CERTIFICATE OF APPROPRIATENESS

Property: 412 Hawthorne Street, Lot 18, Block 1, Westmoreland Subdivision. The property includes a two-story wood frame 2,594 SF single-family residence situated on a 5,871 SF interior lot. Per HCAD

Proposal: Alteration – Exceeded Scope of work of previously administratively approved COA dated March 7, 2023, (attached)

HPO File No. 2023_0014

SHEET: **S1**

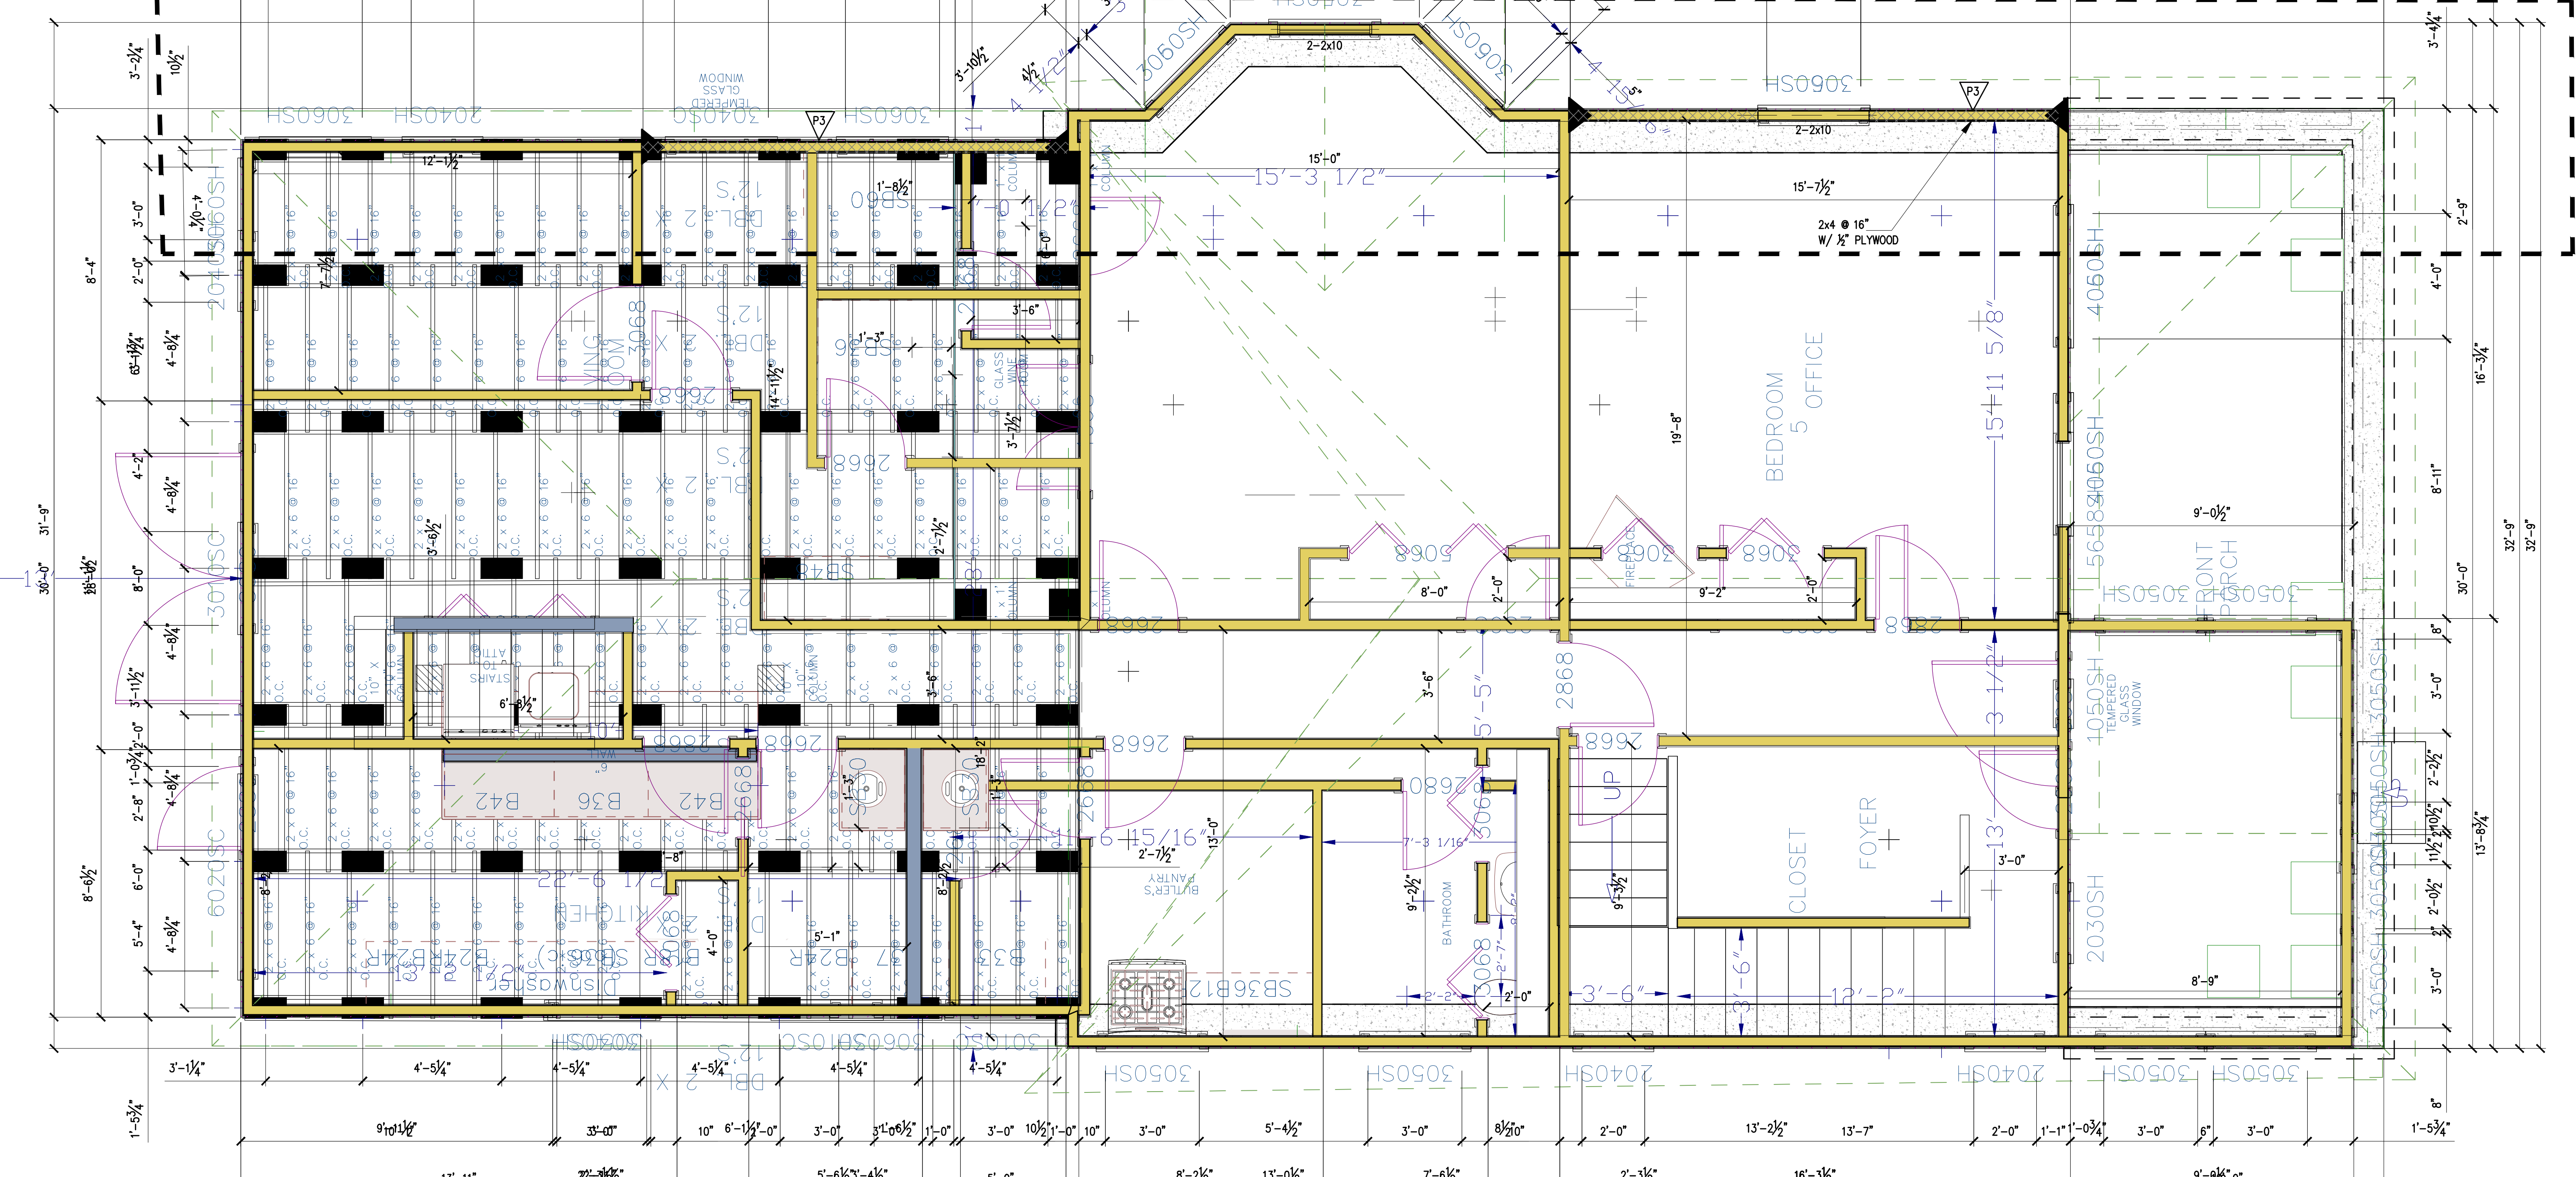
Recommendation: Denial and Issuance of Certificate of Remediation to reframe and sheath the structure per engineer approved plans, re-install the original siding and windows, in the original configurations and per specifications approved by staff.

Please see attached drawings and specifications from engineer regarding the method for framing and sheathing.
